BZA Application Form

BZA Number: 165327

LOCATION OF PROPERTY: 27 Fayerweather St., Cambridge, MA

Petitioner seeks to increase height of roof of both the accessory dwelling unit structure and the existing garage.

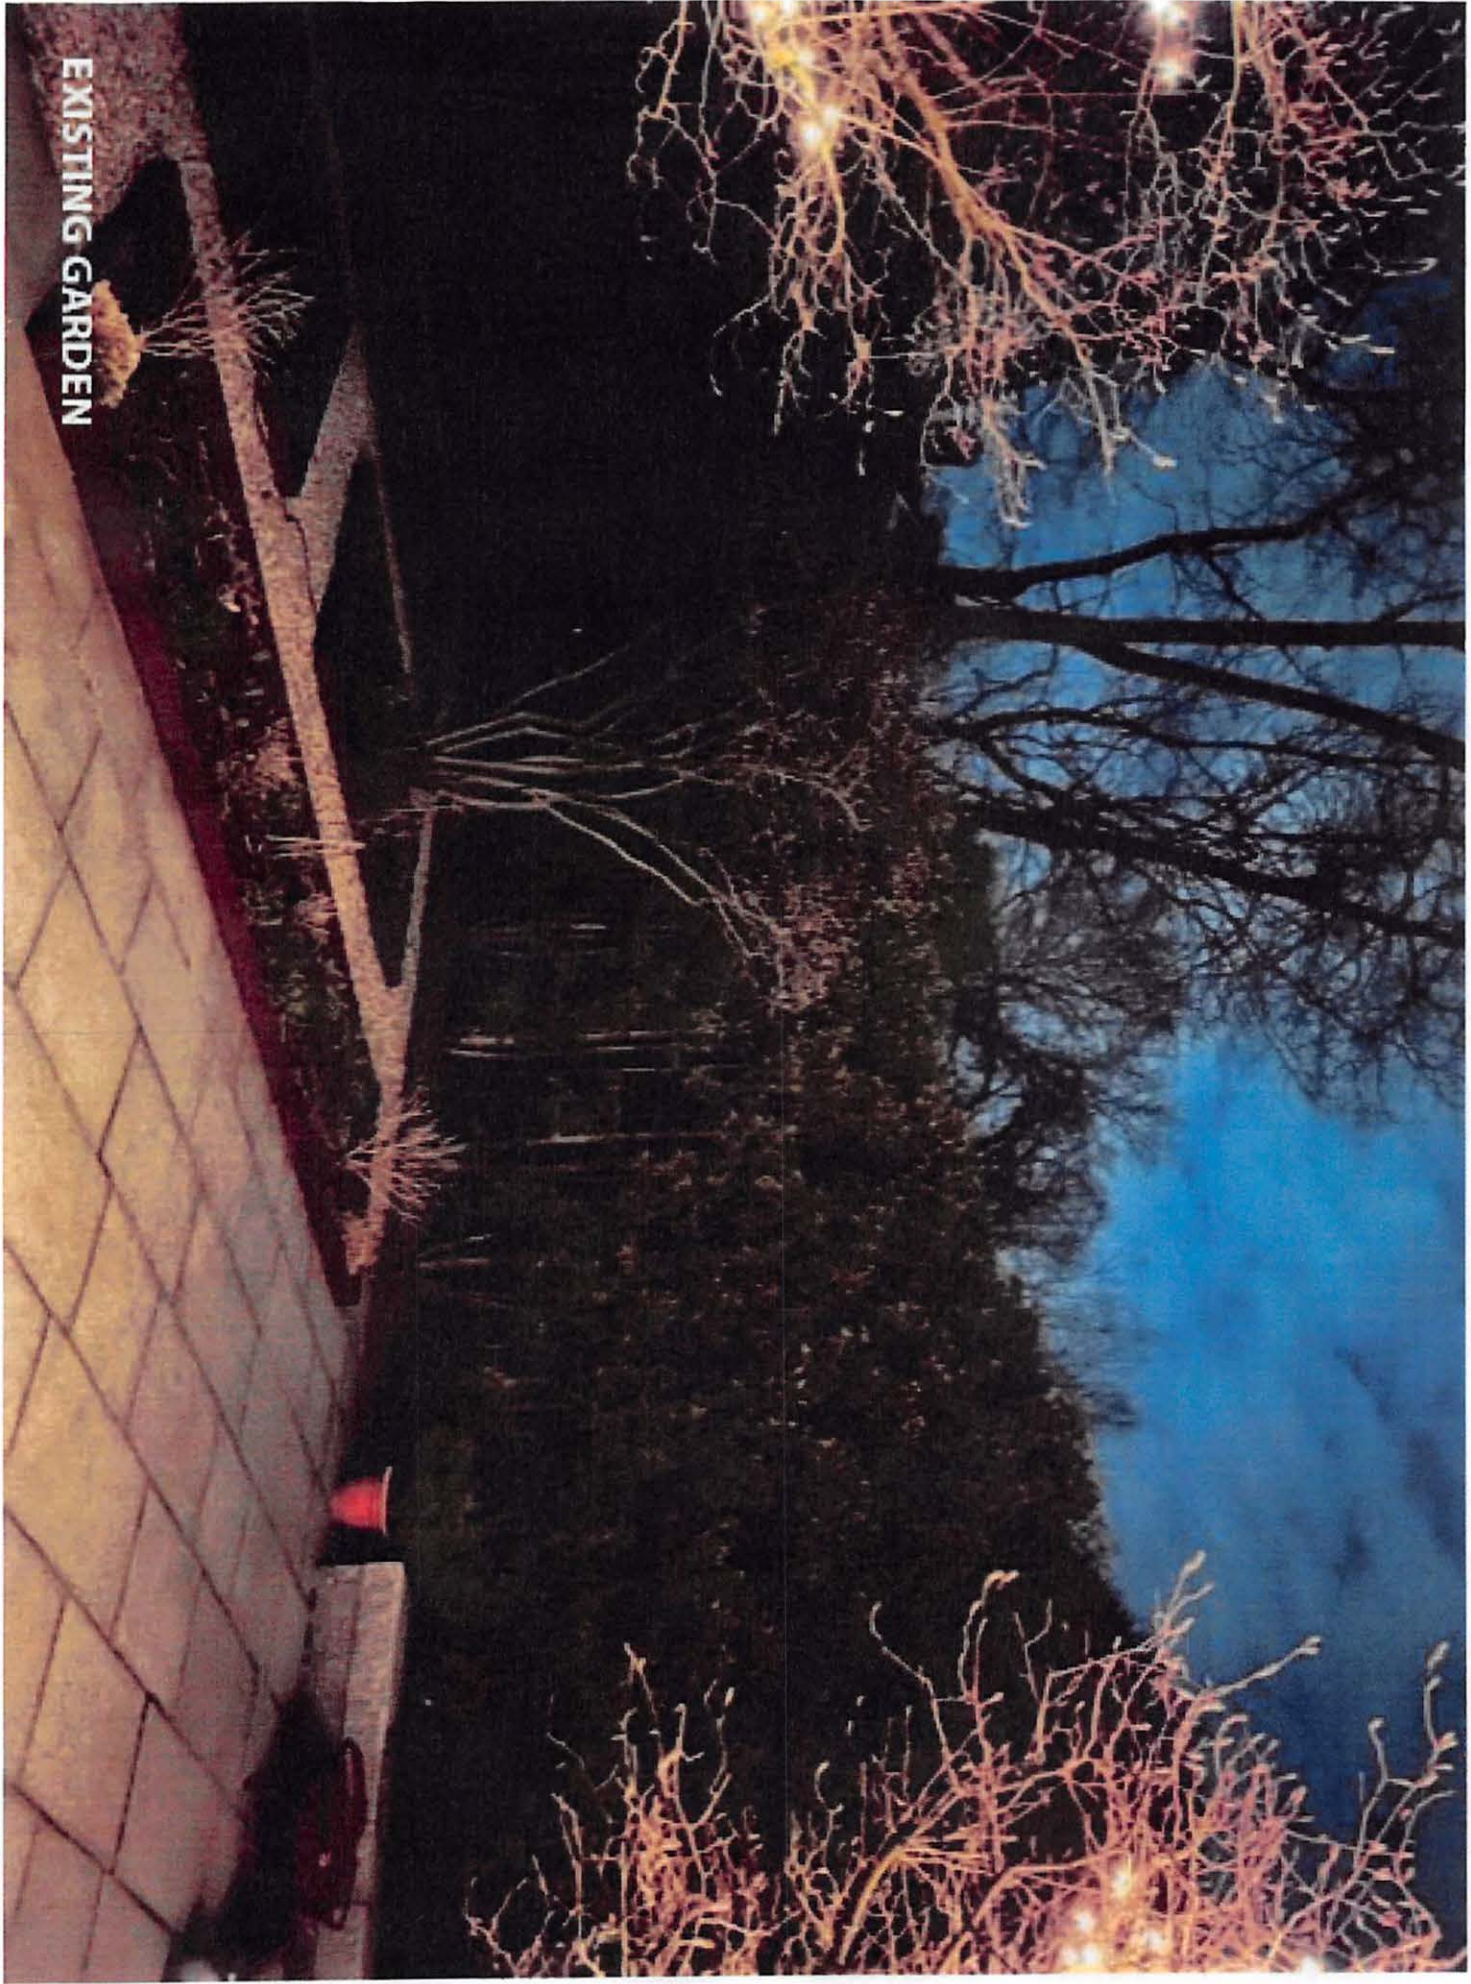
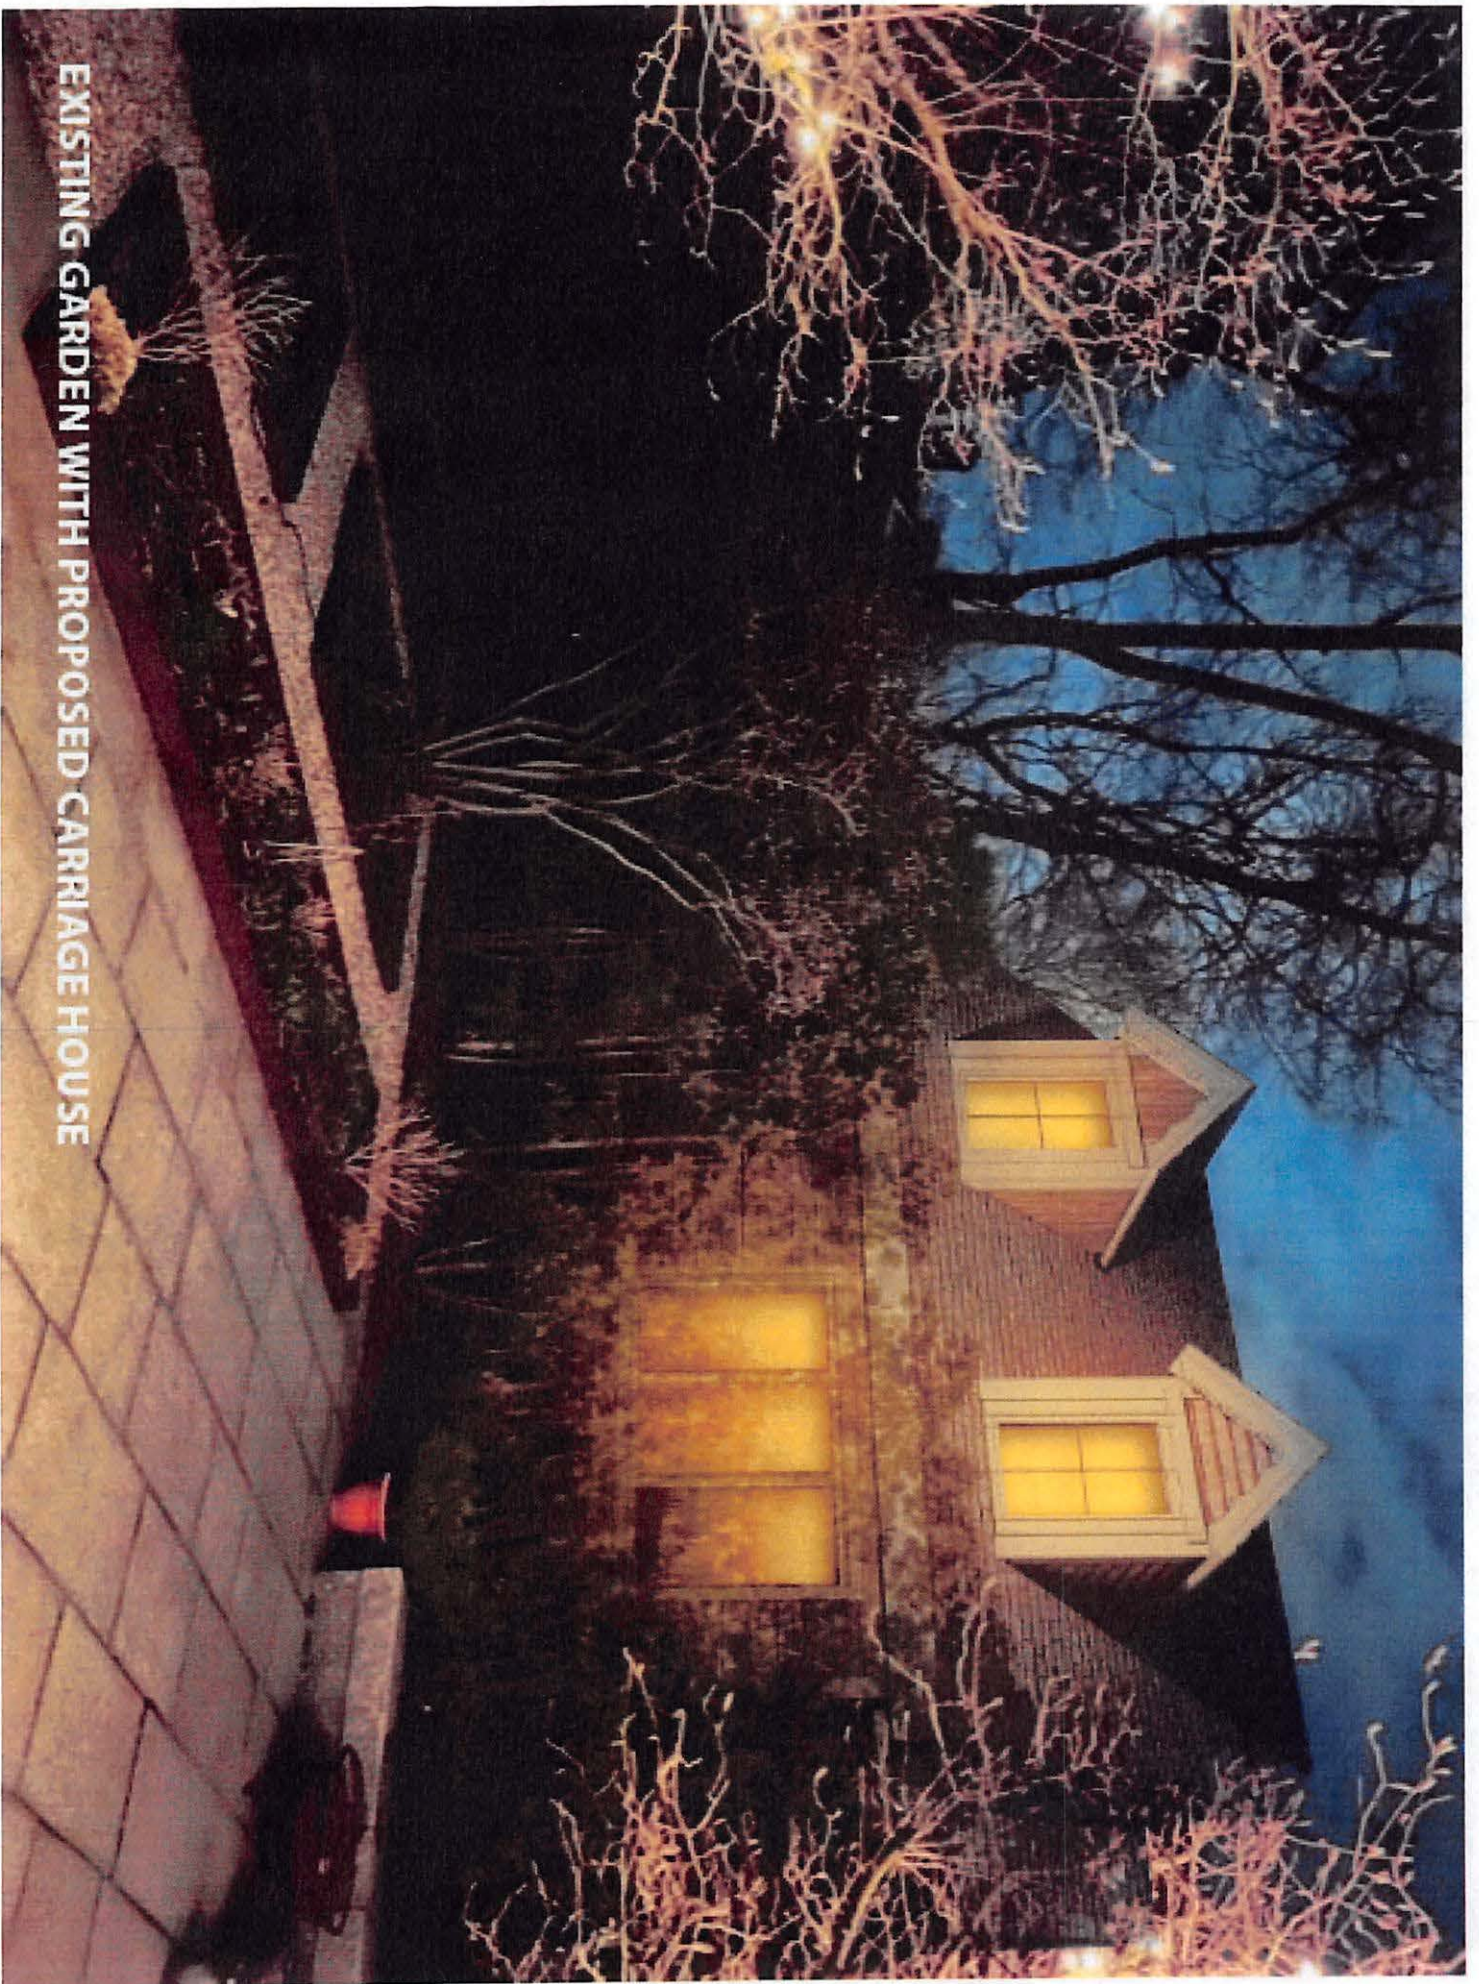
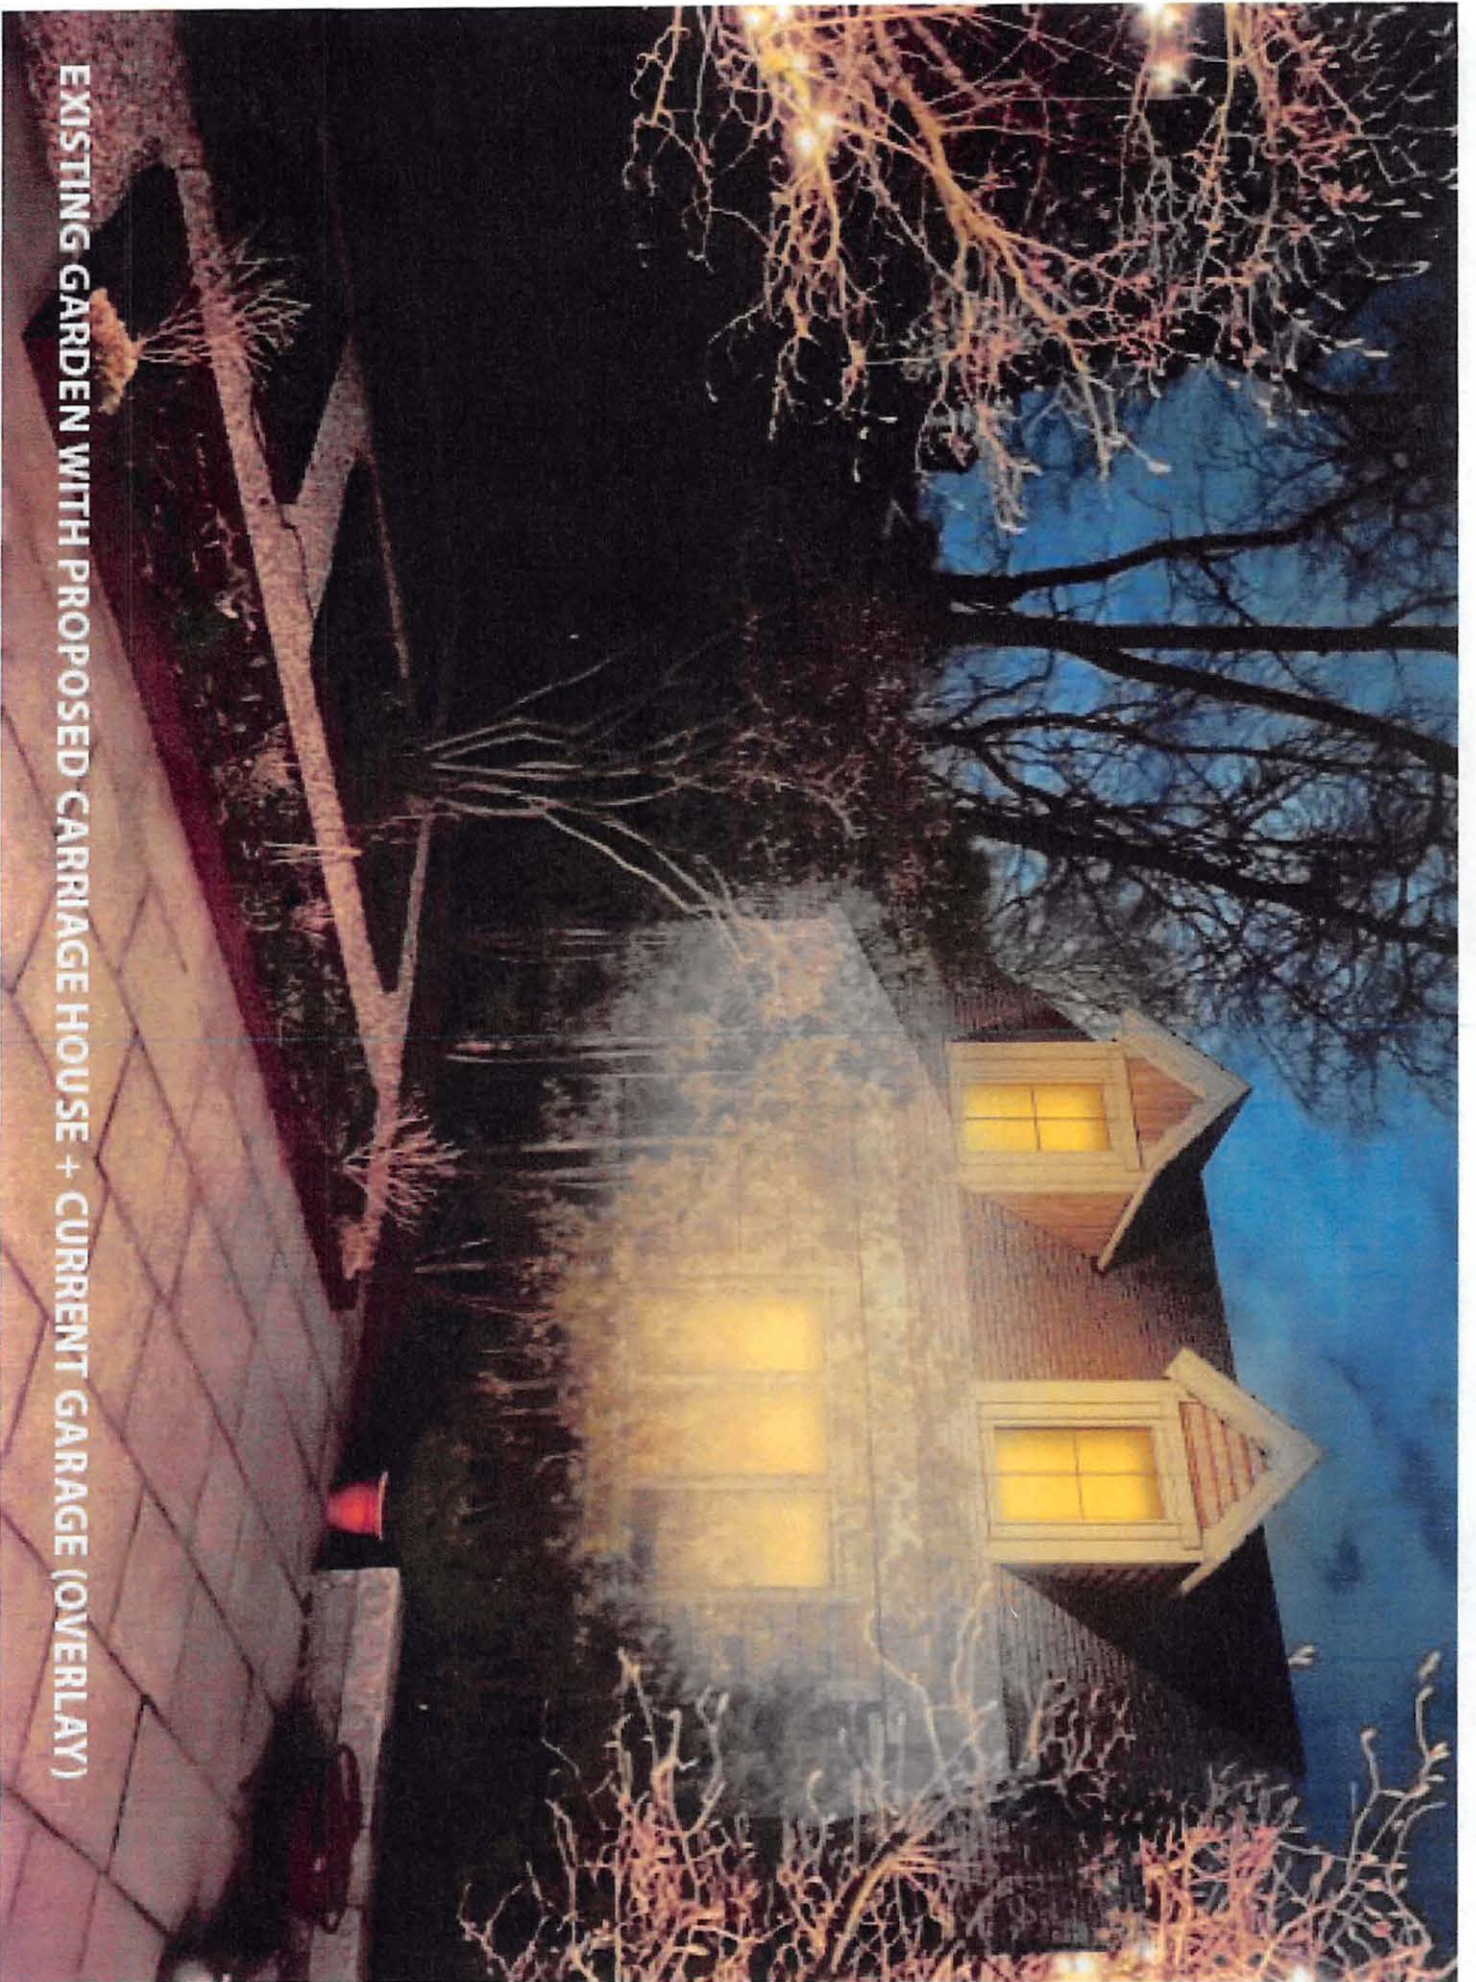
The four panel comparison study that has been prepared by our architect Greg Dennee and submitted to the Board clearly demonstrates the negative impact on our use of our patio and garden. To further illustrate for the Board the adverse effect of raising the height of both the front and rear garages, we engaged the services of our contractor, Kistler and Knapp Builders, Inc. to install four twenty-two foot high poles along the property line. Submitted herewith is a photo of the rear yard patio and garden that depicts the two rear poles placed along the boundary line facing the rear garage, showing the open space that the roof of the proposed accessory building would be filling in. Also submitted herewith are a photo looking from the rear patio toward the two front poles that were placed next on the side of our house facing the front garage, and a photo from the second floor window looking over the existing front garage with the same two front poles in place.

to the building and site plans prepared by Allison Dingman. We exported the model to a program known as Lumion, whereby we simulated lights, landscaping and context. We then matched the photograph supplied by Ms. Flanagan to the Lumion images, using Photoshop, and produced the four “before and after” attached visuals for comparison.
